AMENDMENTS TO THE DRAWINGS:

The attached drawings include changes to FIGS. 1 and 2. The sheet containing FIG. 1 replaces the original sheet including FIG. 1. The sheet containing FIG. 2 replaces the original sheet including FIG. 2.

FIG. 1

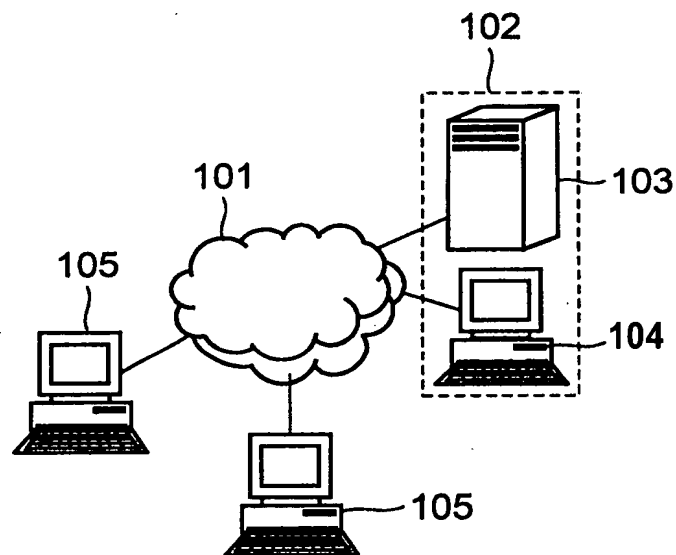
In FIG. 1, an agent terminal shown in the dealer system 102 was mislabeled "103." The agent terminal has been labeled "104," consistently with the Specification. FIG. 2 the dealer server was mislabeled as dealer server "105." The dealer server has been labeled "103," consistently with the Specification. Further, the main memory has been labeled "202," consistently with the Specification.
